# Model Administrative Change Notice

<b>1. Document Number:</b>	ANL-WIS-PA-000001	<b>2. Revision:</b>	02	<b>3. ACN:</b>	01
<b>4. Title:</b>	EBS Radionuclide Transport Abstraction				
<b>5. No. of Pages Attached</b>	115

Figure J-1. Comparison of Cumulative Probabilities in Goethite Sorption Site Density Discrete Distributions from the Uncorrected and Corrected Data Sets

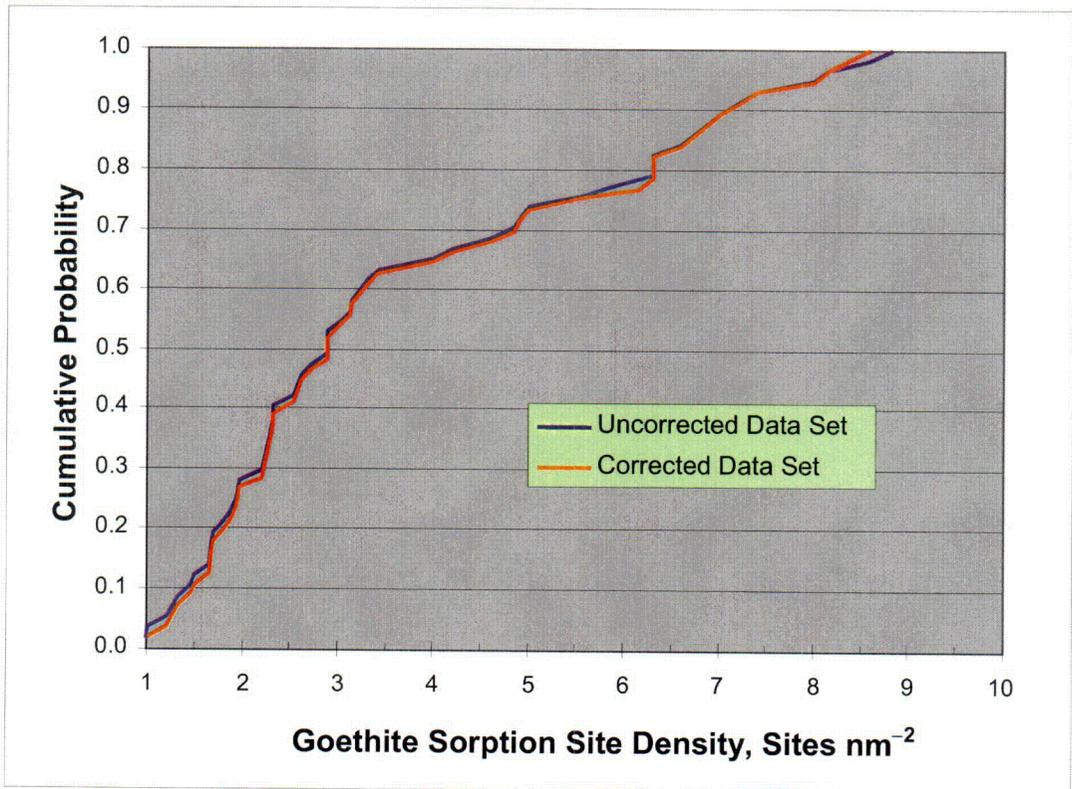
J-6	<p>Labels in legend for Figure J-1: This ACN is being processed in preparation for submission of the report to the NRC in association with AINs for the following KTIs: ENFE 4.03, ENFE 4.06, TSPA 2.02 Comment J-8, TSPA 3.17, and GEN 1.01 Comment 37. Before NRC submission, the report must pass through a public release review, a process that in part involves examining how the document refers to the TSPA. A preliminary review conducted by the Regulatory Compliance department within Licensing determined that Figures J-1 and J-2 and Tables J-1 and J-2 are potentially confusing because they may give the false impression that some of the results shown are generated by the TSPA model. The captions, figure labels, and sources have been changed as necessary to make it clear that the results are from two separate data sets, both of which were generated as product outputs of this report.</p> <p>Figure J-1 replaced with new version having different labels in the legend. "TSPA-LA" has been changed to "Uncorrected Data Set". "EBS RT Abstraction" has been changed to "Corrected Data Set".</p>

J-6	<p>Sources for Figure J-1: This ACN is being processed in preparation for submission of the report to the NRC in association with AINs for the following KTIs: ENFE 4.03, ENFE 4.06, TSPA 2.02 Comment J-8, TSPA 3.17, and GEN 1.01 Comment 37. Before NRC submission, the report must pass through a public release review, a process that in part involves examining how the document refers to the TSPA. A preliminary review conducted by the Regulatory Compliance department within Licensing determined that Figures J-1 and J-2 and Tables J-1 and J-2 are potentially confusing because they may give the false impression that some of the results shown are generated by the TSPA model. The captions, figure labels, and sources have been changed as necessary to make it clear that the results are from two separate data sets, both of which were generated as product outputs of this report.</p> <p>Original REV 02 Text:              Sources: TSPA-LA: Table J-2.                      EBS RT Abstraction: Output DTN: SN0508T0503305.003.</p> <p>Changed to:              Sources: Uncorrected data set: Table J-2.                      Corrected data set: Output DTN: SN0508T0503305.003.</p>

<b>1. Document Number:</b>	ANL-WIS-PA-000001	<b>2. Revision:</b>	02	<b>3. ACN:</b>	01
<b>4. Title:</b>	EBS Radionuclide Transport Abstraction				
J-6	<p>Caption for Figure J-1: This ACN is being processed in preparation for submission of the report to the NRC in association with AINs for the following KTIs: ENFE 4.03, ENFE 4.06, TSPA 2.02 Comment J-8, TSPA 3.17, and GEN 1.01 Comment 37. Before NRC submission, the report must pass through a public release review, a process that in part involves examining how the document refers to the TSPA. A preliminary review conducted by the Regulatory Compliance department within Licensing determined that Figures J-1 and J-2 and Tables J-1 and J-2 are potentially confusing because they may give the false impression that some of the results shown are generated by the TSPA model. The captions, figure labels, and sources have been changed as necessary to make it clear that the results are from two separate data sets, both of which were generated as product outputs of this report.</p> <p>Original REV 02 Text:              Figure J-1. Comparison of Cumulative Probabilities in Goethite Sorption Site Density Discrete Distributions Used in TSPA-LA and Developed in <i>EBS RT Abstraction</i></p> <p>Changed to:              Figure J-1. Comparison of Cumulative Probabilities in Goethite Sorption Site Density Discrete Distributions from the Uncorrected and Corrected Data Sets</p>

Figure J-2. Comparison of Cumulative Probabilities in Goethite Percentage of High-Affinity Sites Discrete Distributions from the Uncorrected and Corrected Data Sets

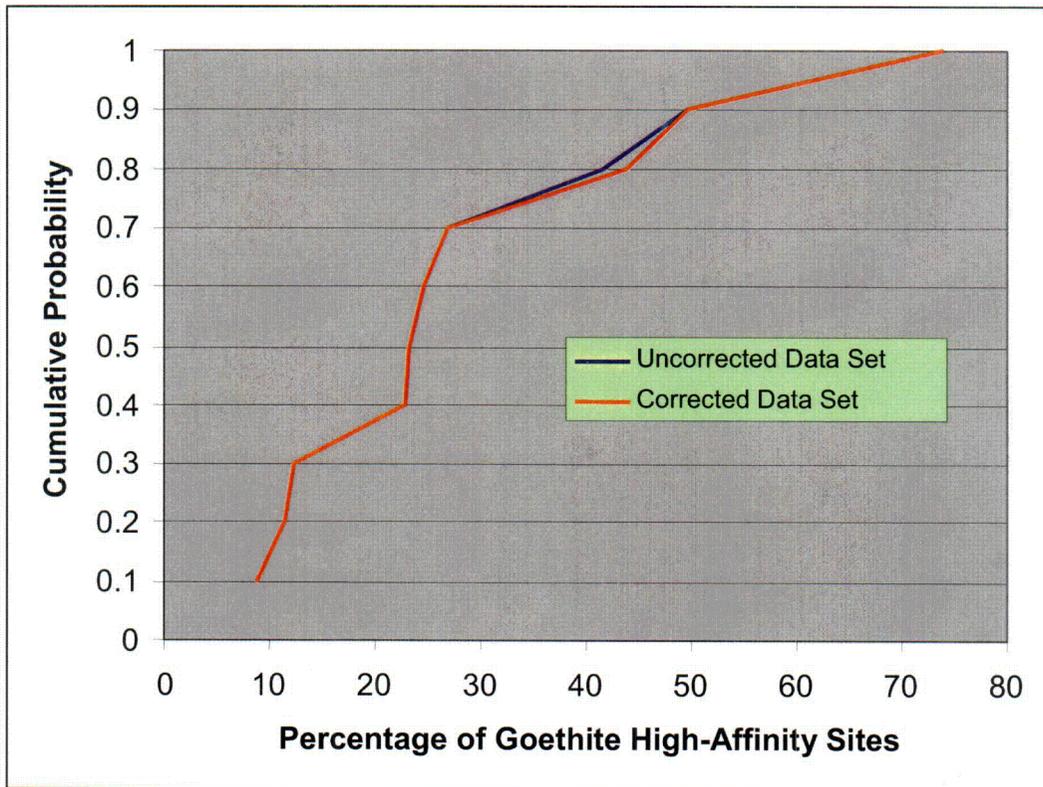
J-9	<p>Labels in legend for Figure J-2: This ACN is being processed in preparation for submission of the report to the NRC in association with AINs for the following KTIs: ENFE 4.03, ENFE 4.06, TSPA 2.02 Comment J-8, TSPA 3.17, and GEN 1.01 Comment 37. Before NRC submission, the report must pass through a public release review, a process that in part involves examining how the document refers to the TSPA. A preliminary review conducted by the Regulatory Compliance department within Licensing determined that Figures J-1 and J-2 and Tables J-1 and J-2 are potentially confusing because they may give the false impression that some of the results shown are generated by the TSPA model. The captions, figure labels, and sources have been changed as necessary to make it clear that the results are from two separate data sets, both of which were generated as product outputs of this report.</p> <p>Figure J-2 replaced with new version having different labels in the legend. "TSPA-LA" has been changed to "Uncorrected Data Set". "EBS RT Abstraction" has been changed to "Corrected Data Set".</p>

J-9	<p>Sources for Figure J-2: This ACN is being processed in preparation for submission of the report to the NRC in association with AINs for the following KTIs: ENFE 4.03, ENFE 4.06, TSPA 2.02 Comment J-8, TSPA 3.17, and GEN 1.01 Comment 37. Before NRC submission, the report must pass through a public release review, a process that in part involves examining how the document refers to the TSPA. A preliminary review conducted by the Regulatory Compliance department within Licensing determined that Figures J-1 and J-2 and Tables J-1 and J-2 are potentially confusing because they may give the false impression that some of the results shown are generated by the TSPA model. The captions, figure labels, and sources have been changed as necessary to make it clear that the results are from two separate data sets, both of which were generated as product outputs of this report.</p> <p>Original REV 02 Text:              Sources: TSPA-LA: Table J-2.                      EBS RT Abstraction: Output DTN: SN0508T0503305.003.</p> <p>Changed to:              Sources: Uncorrected data set: Table J-2.                      Corrected data set: Output DTN: SN0508T0503305.003.</p>

<b>1. Document Number:</b>	ANL-WIS-PA-000001	<b>2. Revision:</b>	02	<b>3. ACN:</b>	01
<b>4. Title:</b>	EBS Radionuclide Transport Abstraction				
J-9	<p>Caption for Figure J-2: This ACN is being processed in preparation for submission of the report to the NRC in association with AINs for the following KTIs: ENFE 4.03, ENFE 4.06, TSPA 2.02 Comment J-8, TSPA 3.17, and GEN 1.01 Comment 37. Before NRC submission, the report must pass through a public release review, a process that in part involves examining how the document refers to the TSPA. A preliminary review conducted by the Regulatory Compliance department within Licensing determined that Figures J-1 and J-2 and Tables J-1 and J-2 are potentially confusing because they may give the false impression that some of the results shown are generated by the TSPA model. The captions, figure labels, and sources have been changed as necessary to make it clear that the results are from two separate data sets, both of which were generated as product outputs of this report.</p> <p>Original REV 02 Text:</p> <p style="padding-left: 40px;">Figure J-2. Comparison of Cumulative Probabilities in Goethite Percentage of High-Affinity Sites Discrete Distributions Used in TSPA-LA and Developed in <i>EBS RT Abstraction</i></p> <p>Changed to:</p> <p style="padding-left: 40px;">Figure J-2. Comparison of Cumulative Probabilities in Goethite Percentage of High-Affinity Sites Discrete Distributions from the Uncorrected and Corrected Data Sets</p>
